DATE: December 2, 2015

SUBJECT: Guide for Paving Shoulders Under Bridges – Standard

Drawings Revision and Design Manual Changes

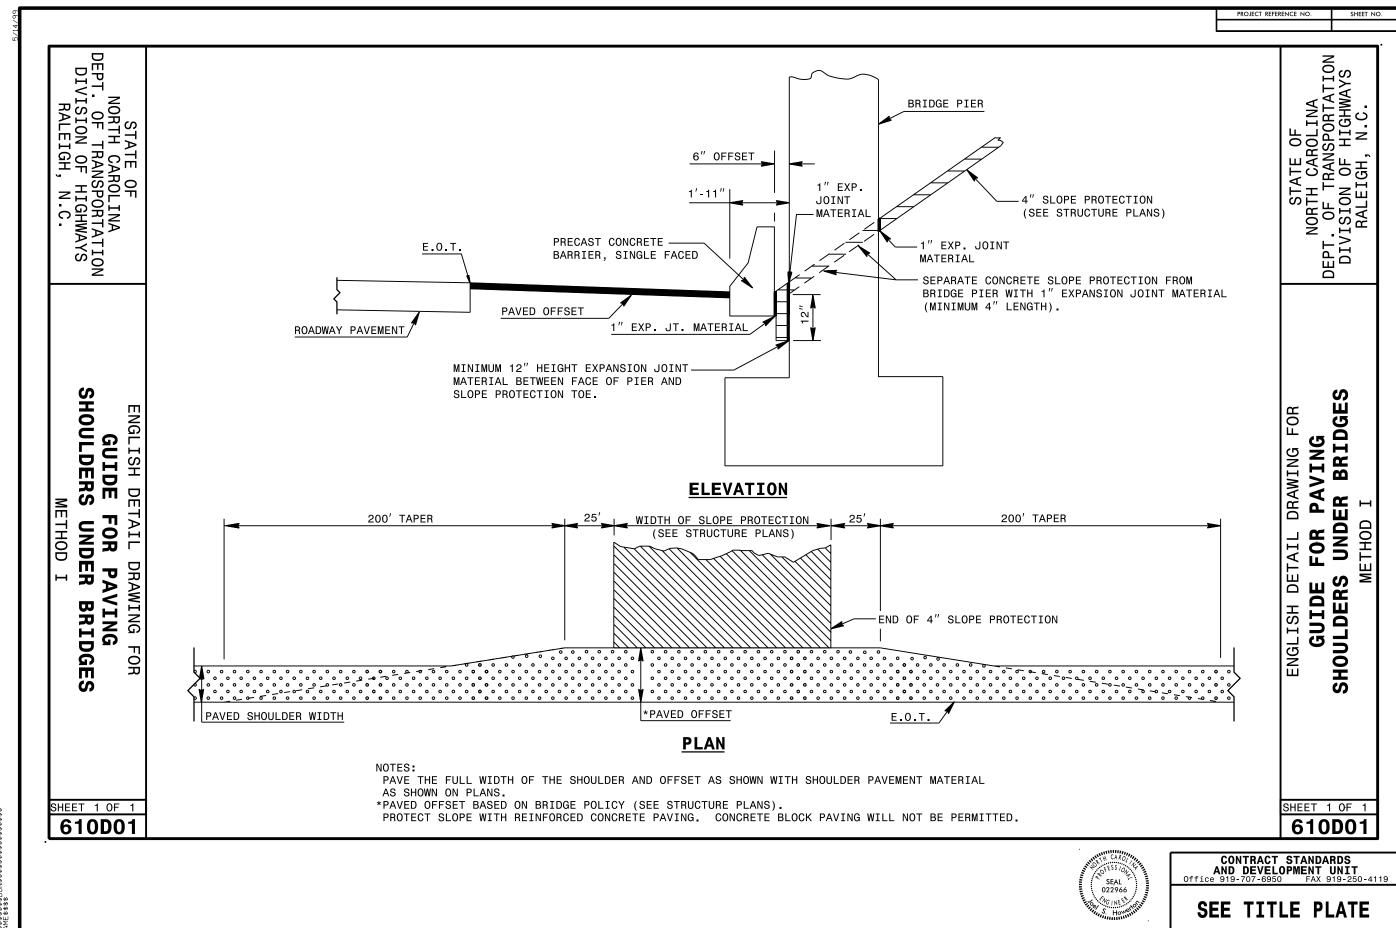
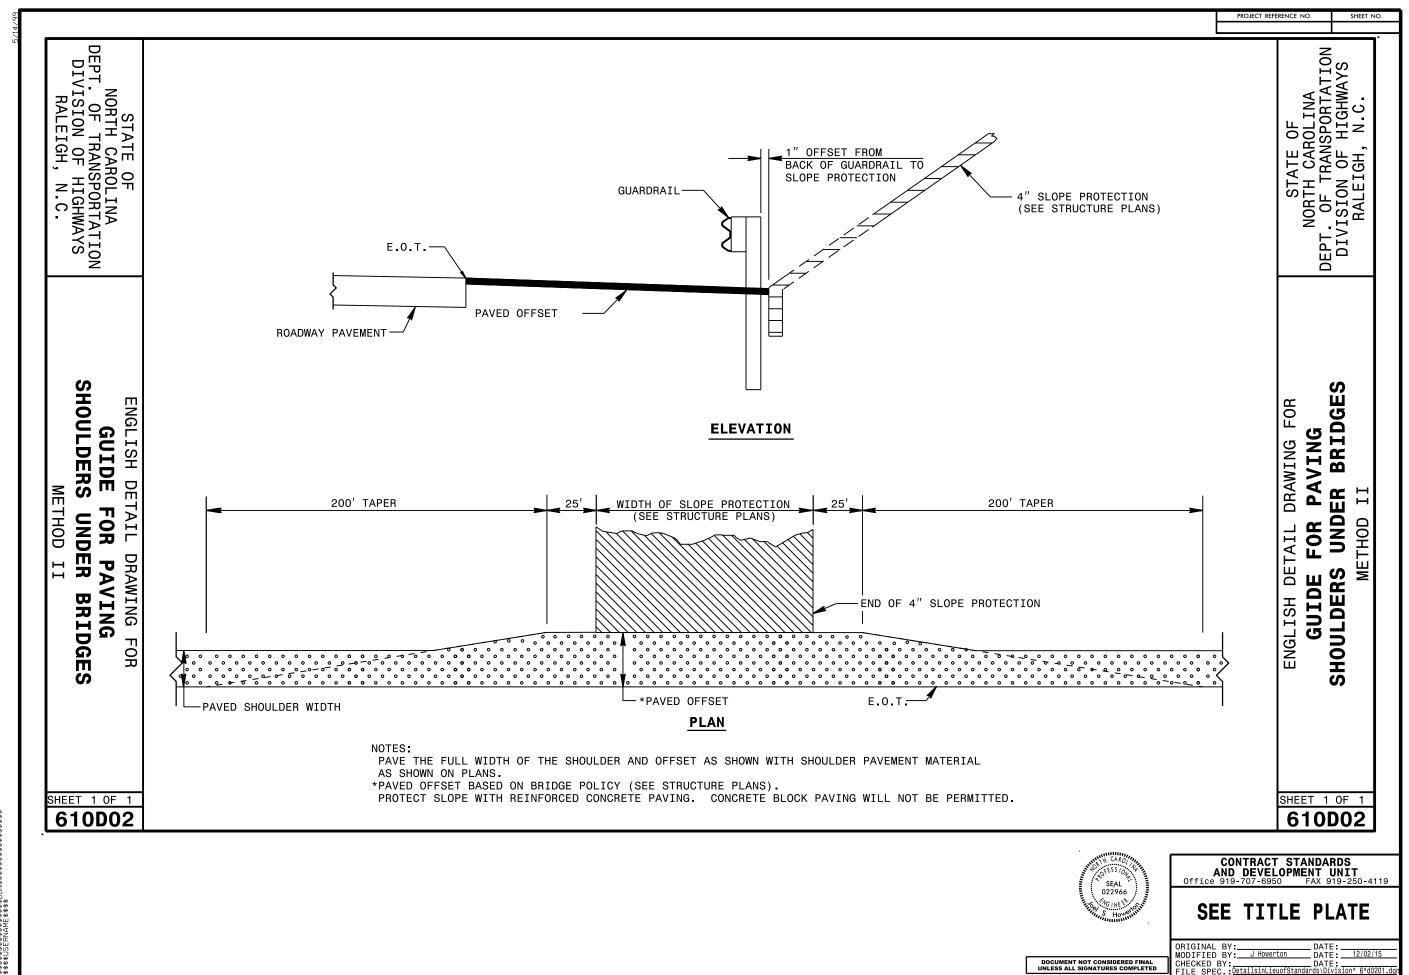
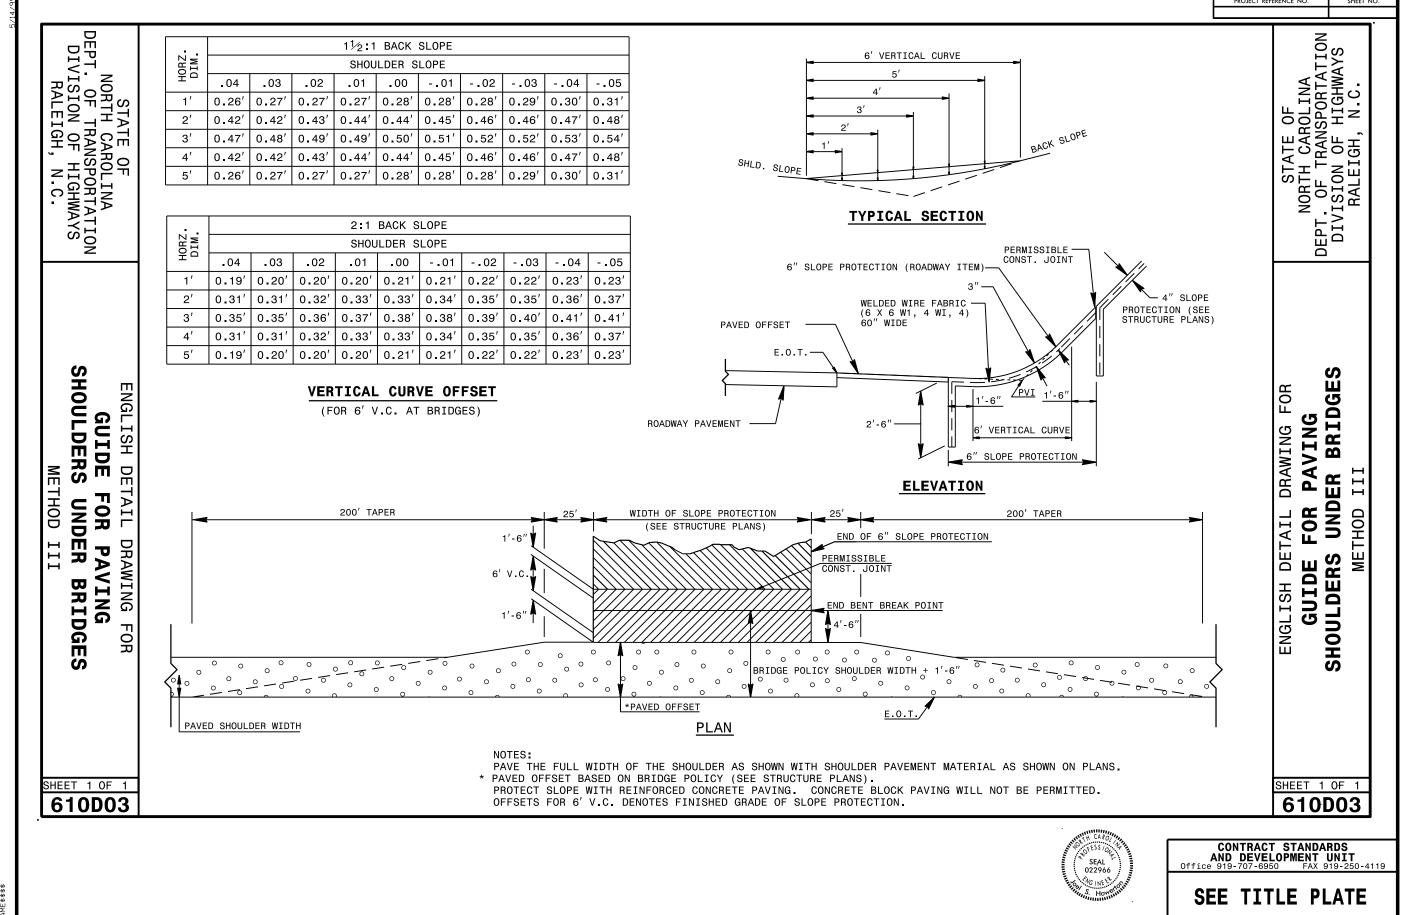
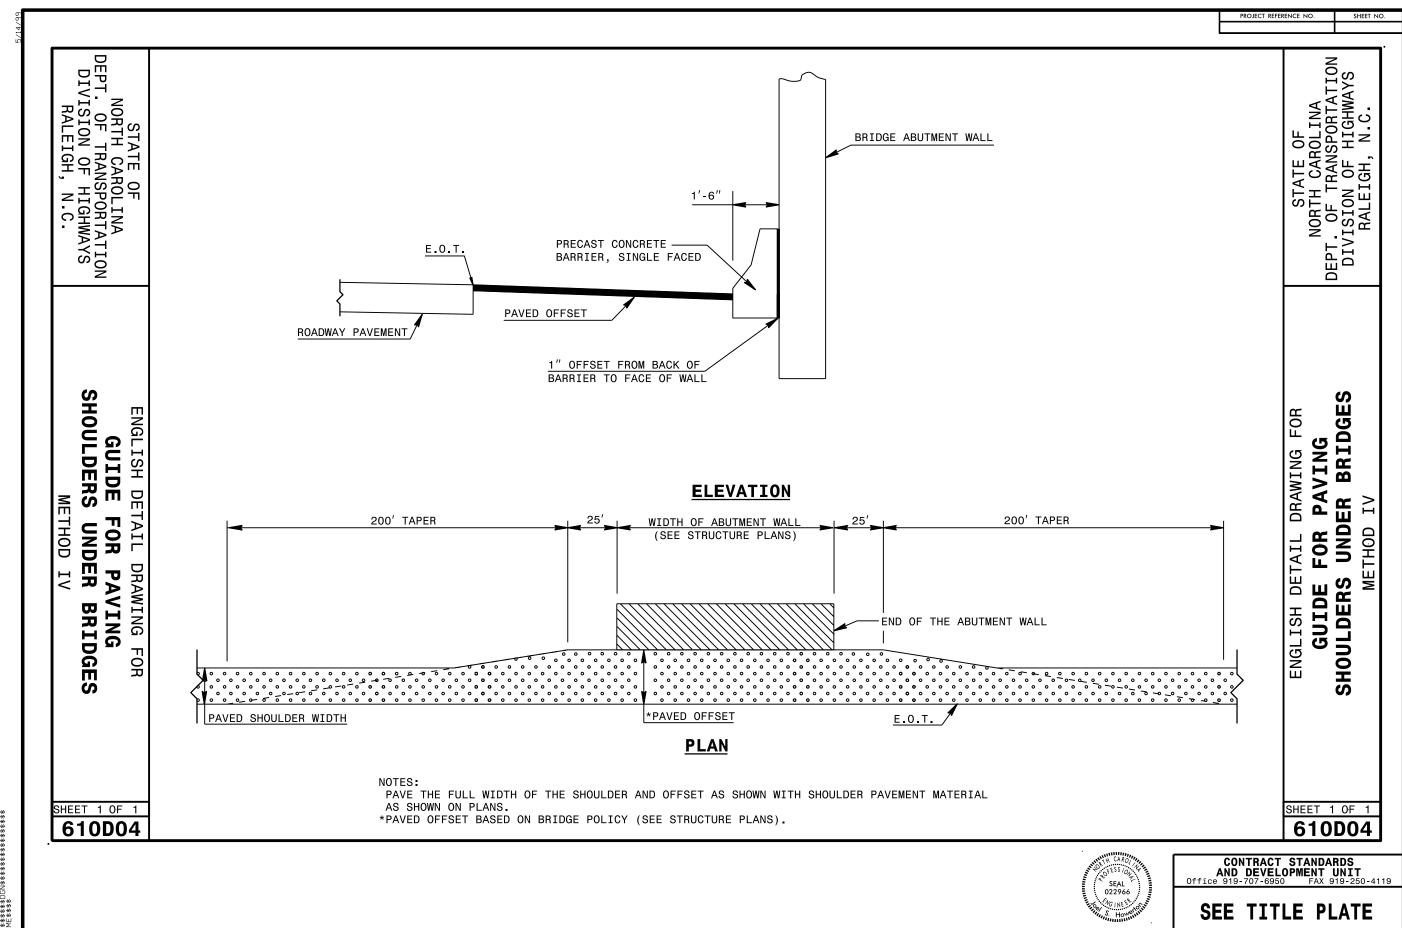
This is to advise you of a recent revision to the 2012 Roadway Standard Drawings. The revision affects Standard Drawings 610.01, 610.02, and 610.03 – Guide for Paving Shoulders under Bridges Method I, Method II, and Method III, respectively. It also includes the addition of a new standard drawing – Guide for Paving Shoulders under Bridges Method IV.

New special details (610D01, 610D02, 610D03, 610D04) which address the revisions made to Standard Drawings are now available under Connect NCDOT – Resources – Specifications – 2012 Roadway Standard Drawings - 2012 Revisions to Roadway Standard Drawings. Please use these special details in lieu of Standard Drawings effective with the March 2016 Let (December 8, 2015 turn-in).

FIGURE 1R 6-1

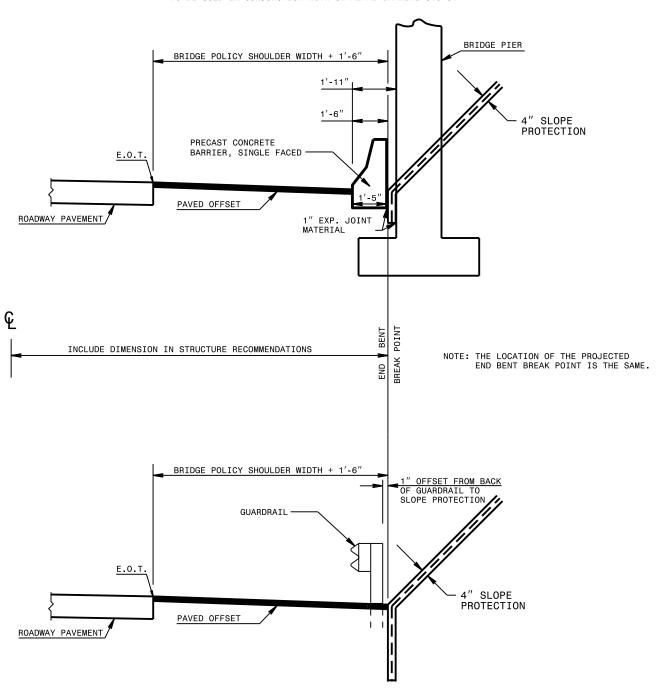
This paragraph was added with the 12-02-15 revision

The paved offset will vary based on the proposed end bent shoulder treatment under the bridge (bridge pier, guardrail, 6" slope protection, abutment wall). See 6-1, Figures F-1R and F-1S for details to be used with the Roadway Standard Drawings for clarification. The break point for the end bent slope is the same in each case. This will result in a consistent bridge length regardless of the end bent shoulder treatment.
